Re: Rough-In Reinspection — 250 Koerner Lane, Erwin, NC

Permit #: SFD2503-0086

Project: 250 Koerner Lane – Rough-In Inspection Response

Subject: Calculations Supporting Adequacy of Single King Stud At Front Door Frame:

Job	Truss	Truss Type	Qty	Ply	Job Reference (optional)
4492414 3-18-25	A09	Piggyback Base	1	1	I75104444

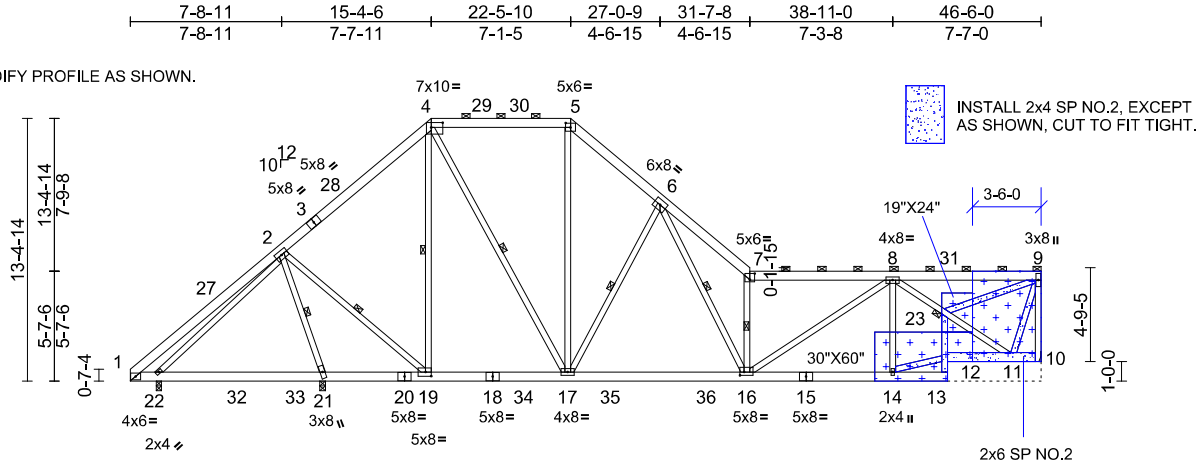
REPAIR: MODIFY PROFILE AS SHOWN.

Job	Truss	Truss Type	Qty	Ply	Job Reference (optional)
4492414 3-18-25	A010	Piggyback Base	1	1	I75104445

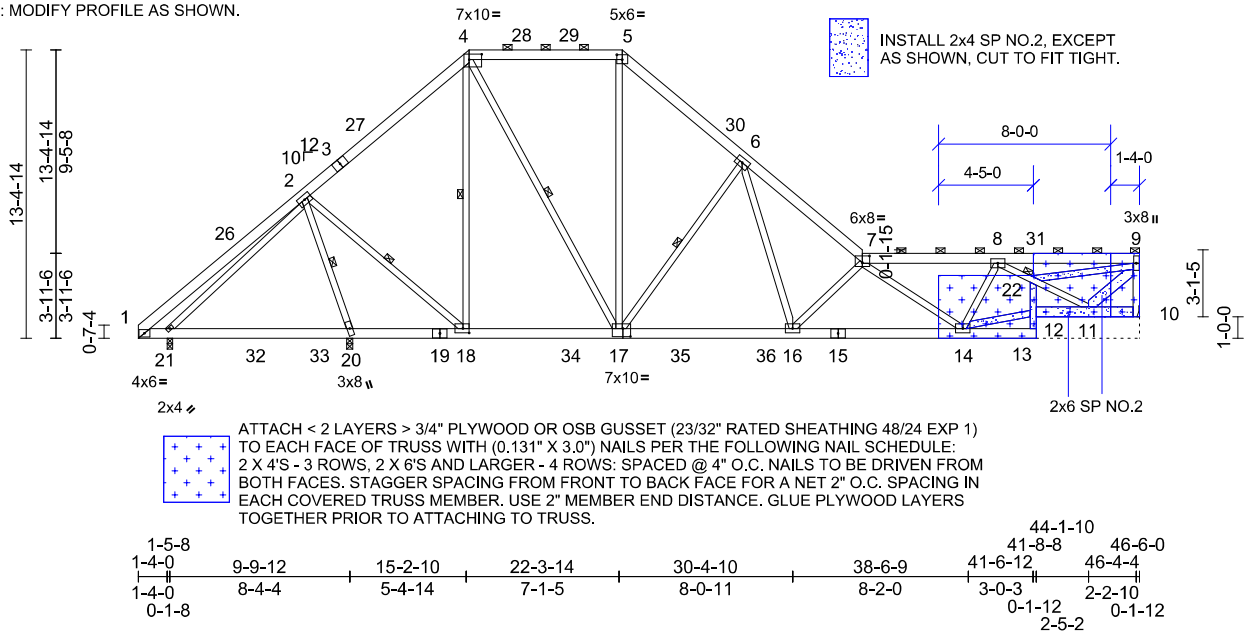
REPAIR: MODIFY PROFILE AS SHOWN.
